## STAFF REPORT

**Date:** February 24, 2015  
**To:** Bryan H. Montgomery, City Manager  
**From:** Kenneth W. Strelow, Senior Planner  
**SUBJECT:** Cedar Glenn Estates Design Review (DR 09-14)

This is a request by John Kiper of Kiper Development Inc. ("Applicant") for design review approval of house plans and architecture, and a development plan (neighborhood plotting plan) for 20 entitled lots located within proposed Final Map 9104 (approved Tentative Map 9104) on the property known as "Cutino Property." The 4.74 acre project is located north of Cedar Glenn Drive in Live Oak Ranch, and abuts the west edge of Shady Oak Community Park. The project site is zoned P-1 (Planned Development) District. APN: 034-250-008.

Figure 1. Street Scene.

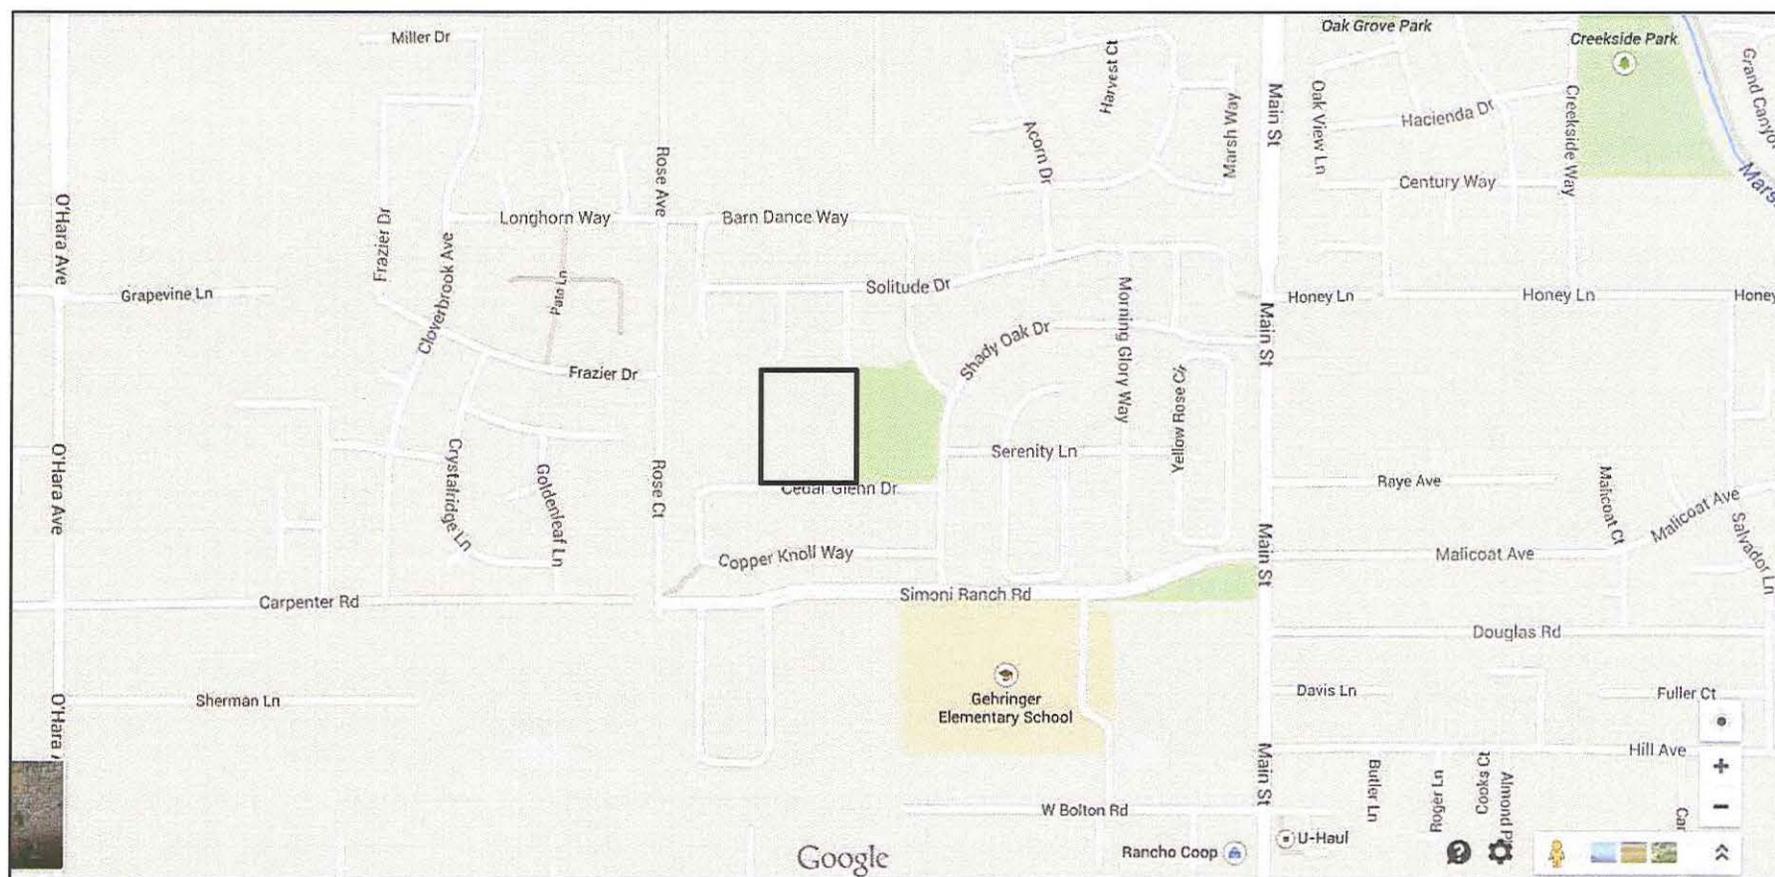
replaces front gables with hip elements, also includes stucco exterior walls, and uses a different style stone veneer accent than Plan B. Figure 1 shows the Street Scene provided on the applicant's plans.
